AGENDA

ARCHITECTURAL REVIEW BOARD MEETING

TO: Planning and Zoning Commission
DATE: November 12, 2024
APPLICANT: Joanne Vuckovic; *Pregnancy Resource Center*
CASE NUMBER: SP2024-042; *Site Plan for 1010 Ridge Road (Pregnancy Resource Center)*

TO: Planning and Zoning Commission
DATE: November 12, 2024
APPLICANT: Jake Hodges; Kimley-Horn
CASE NUMBER: SP2024-043; *Site Plan for Rockwall Medical Building*

SITE PLAN BUILDING EXPANSION & LANDSCAPING
PREGNANCY RESOURCE CENTER
1010 RIDGE ROAD
CITY OF ROCKWALL
ROCKWALL COUNTY, TEXAS

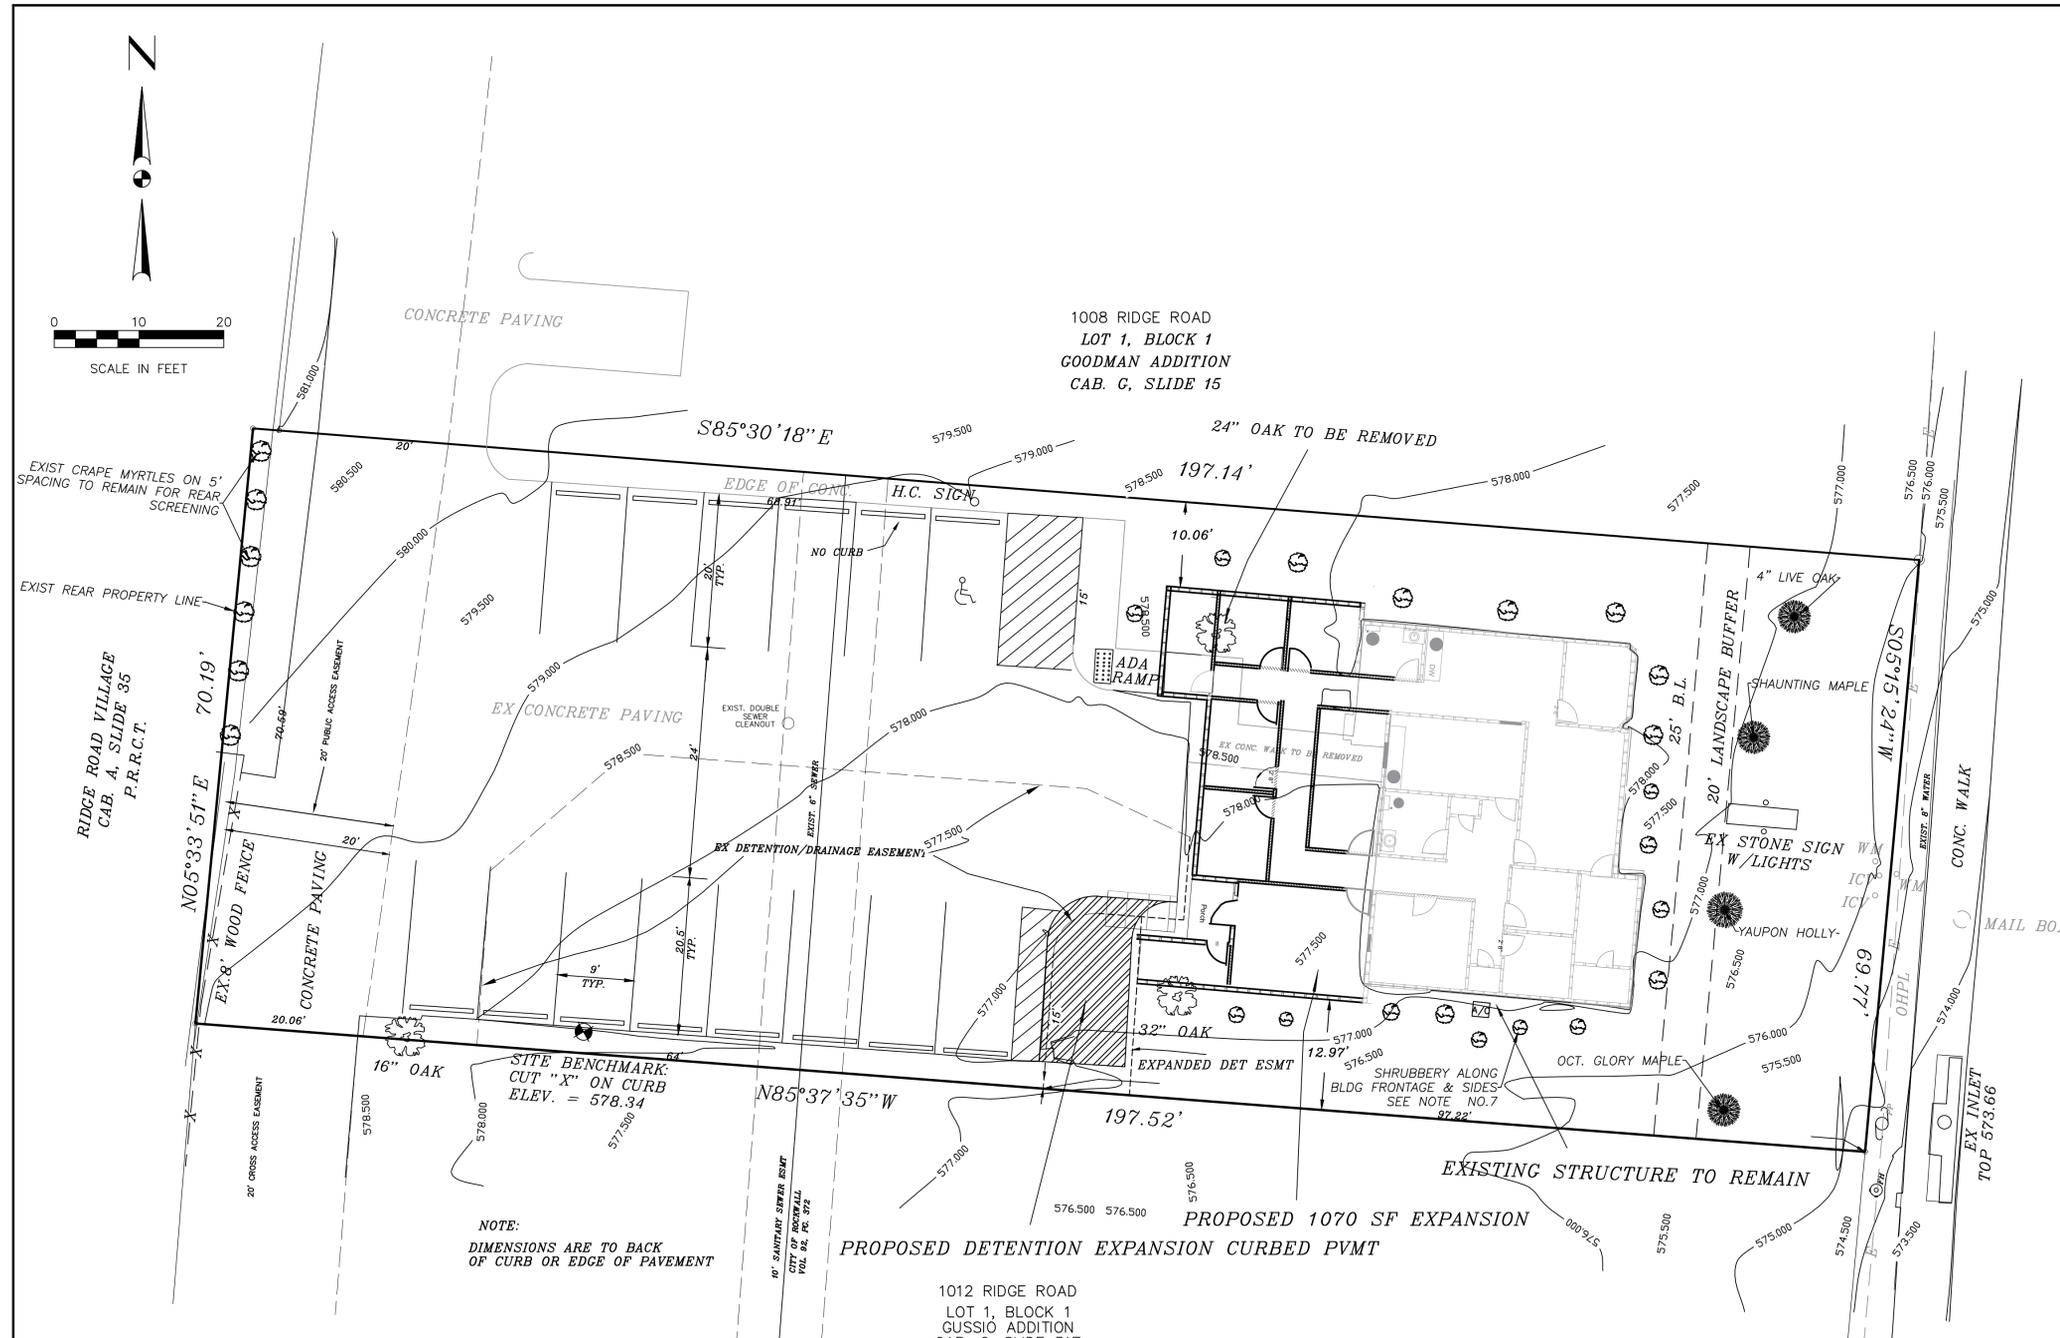
- (b) Cementitious Materials. According to Subsection 06.02(C)(2), *Cementitious Materials*, of Article 05, *District Development Standards*, of the Unified Development Code (UDC), "(t)he use of cementitious materials (i.e. stucco, cementitious lap siding, or similar materials approved by the Director of Planning and Zoning or his/her designee) shall be limited to 50.00% of the building's exterior façade..." In this case, the applicant has not provided masonry percentages for each façade; however, two (2) of the facades utilize 100.00% Hardie Board lap siding and the overall structure does not appear to meet this requirement. Based on this, this aspect of the applicant's request will require a variance from the Planning and Zoning Commission.

- (c) Stone. A minimum of 20.00% natural or quarried stone is required on all building facades; however, the Planning and Zoning Commission, upon recommendation from the Architectural Review Board (ARB), may grant the use of a high quality manufactured or cultured stone in lieu of natural or quarried stone if it is determined that the application of the manufactured or cultured stone will be complimentary and integral to the design of the building. In this case, the applicant does not meet the requirement for 20.00% natural or quarried stone on two (2) facades of the proposed building and is proposing a manufactured or cultured stone product for the remaining two (2) sides of the building. This will require a Variance from the Planning and Zoning Commission.

On October 29, 2024, the Architecture Review Board (ARB) reviewed the proposed building elevations and recommended that the applicant provide a material sample board, a colored rendering of the proposed building, and add a double window in the front of the building to create symmetry. The Architectural Review Board will review the updated building elevations and material sample board and provide a recommendation before action is taken by the Planning and Zoning Commission at the November 12, 2024 meeting.

1 NORTH ELEVATION (FACING STATE HIGHWAY 276 - PRIMARY FACADE)
1" = 10'-0"

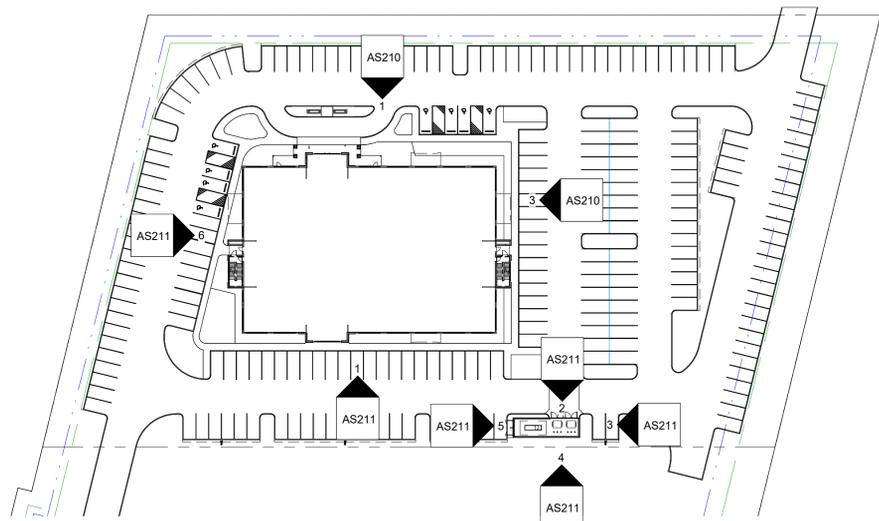
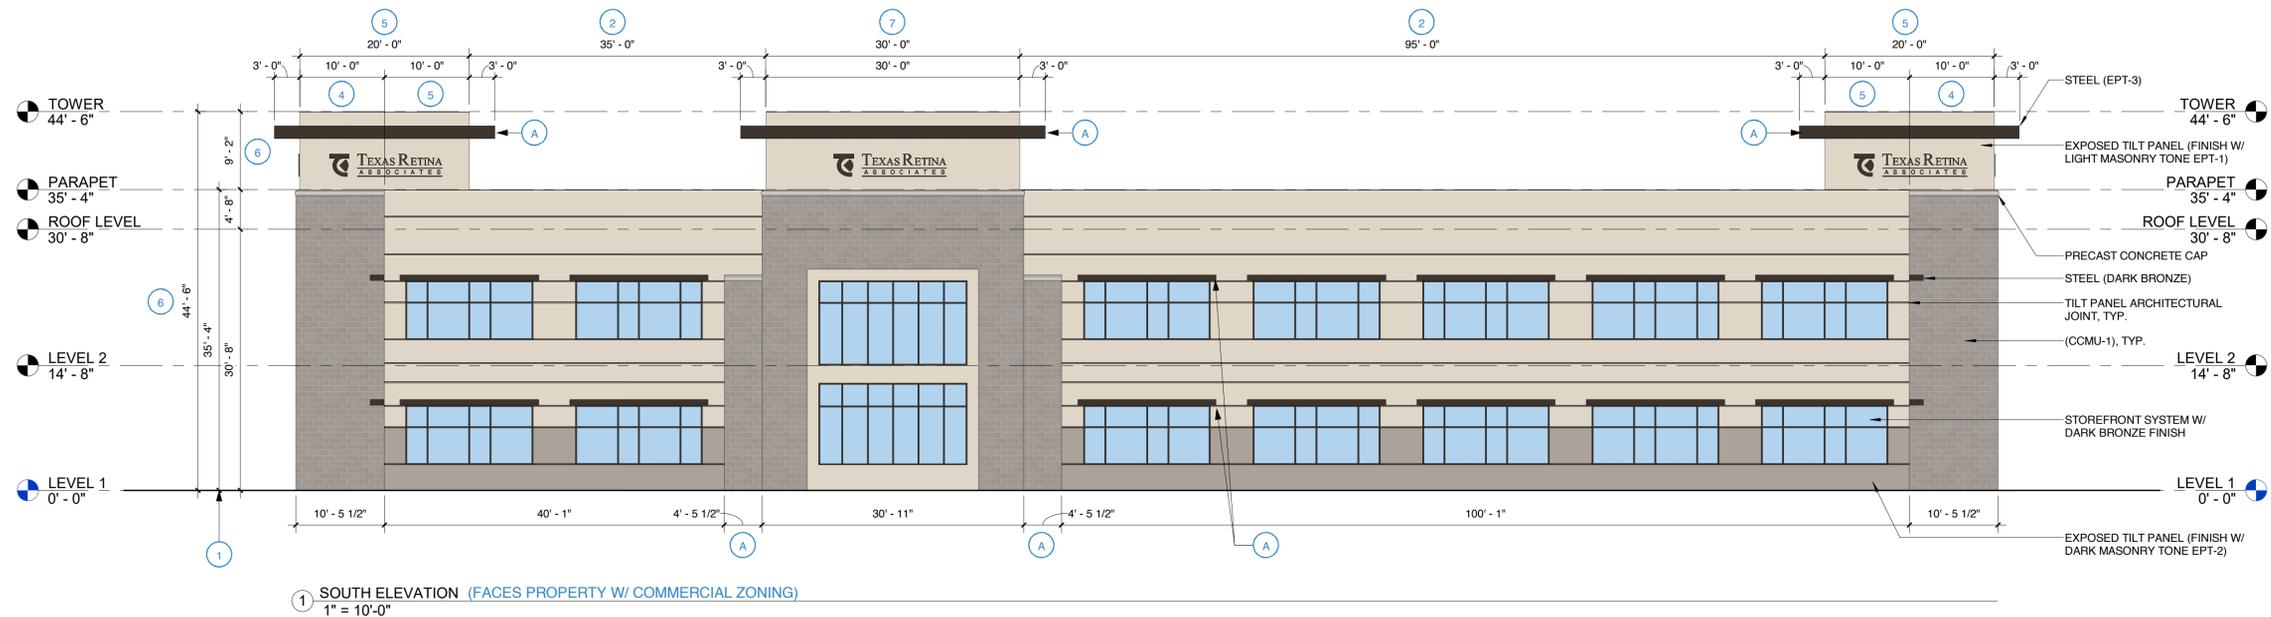
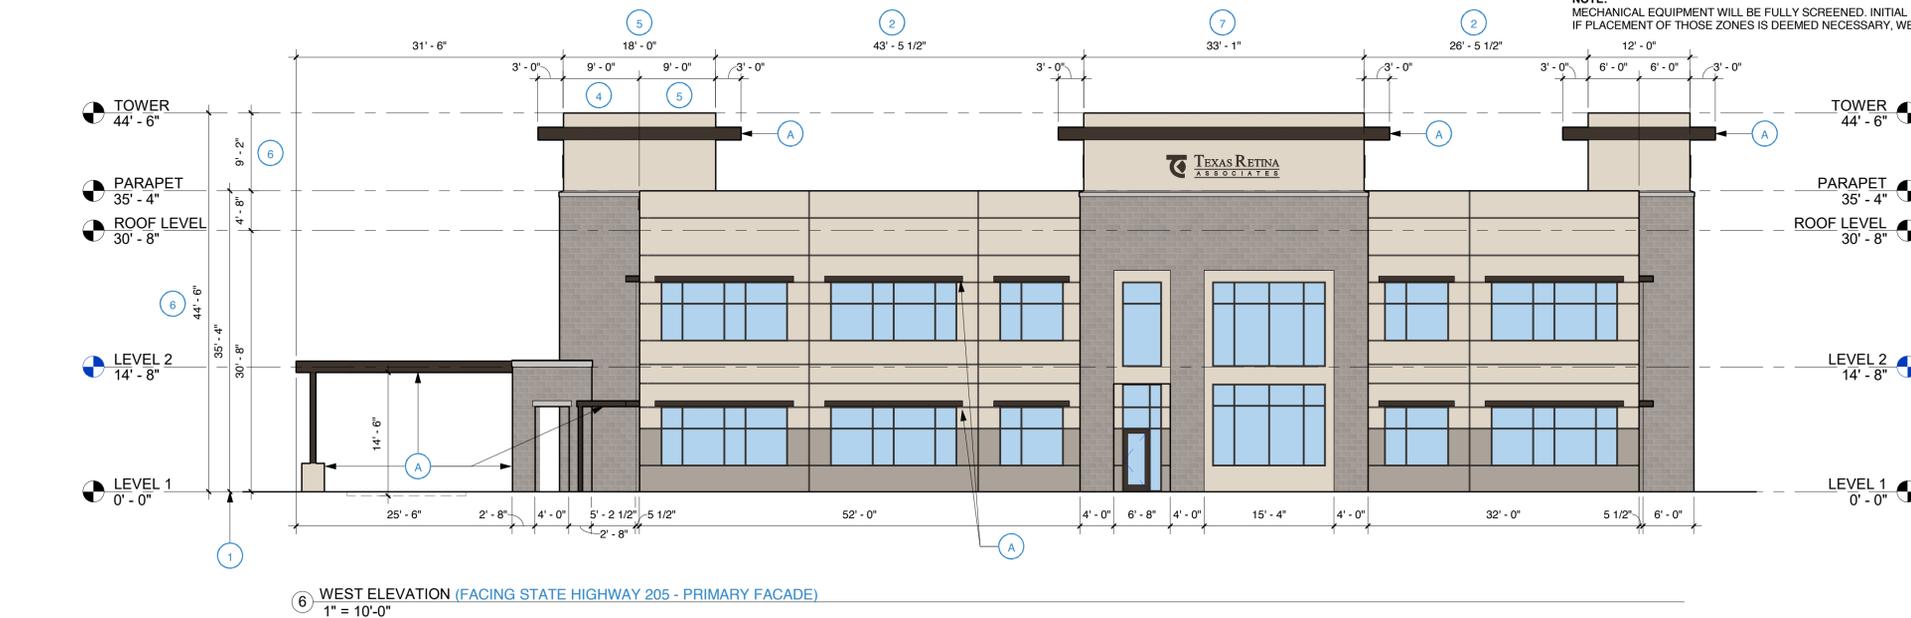
- (a) Stone. According to Subsection 05.01(A), *Materials and Masonry Composition*, of Article 05, *District Development Standards*, of the Unified Development Code (UDC), "(a) minimum of 20% natural or quarried stone is required on all building façades..." In this case, the material sample board provided by the applicant shows the use of burnished block on 100.00% of the exterior of the building. Based on this, the applicant will require a variance from the Planning and Zoning Commission.

On October 29, 2024, the Architecture Review Board (ARB) reviewed the proposed building elevations provided by the applicant and recommended that the applicant provide a rendering of the building with a solid color theme. The applicant has provided updated elevations that will be reviewed by the Architectural Review Board (ARB) prior to the *November 12, 2024* Planning and Zoning Commission meeting.

- ⑦ ADDITIONAL ARCHITECTURAL ELEMENT
- ADDITIONAL NOTES:**
- SEEKING VARIANCE/ALTERNATIVE COMPLIANCE FOR EXPOSED CONCRETE TILT PANEL VS. MASONRY
 - SEEKING VARIANCE/ALTERNATIVE COMPLIANCE FOR CUSTOM CONCRETE MASONRY UNITS FOR 20% STONE.
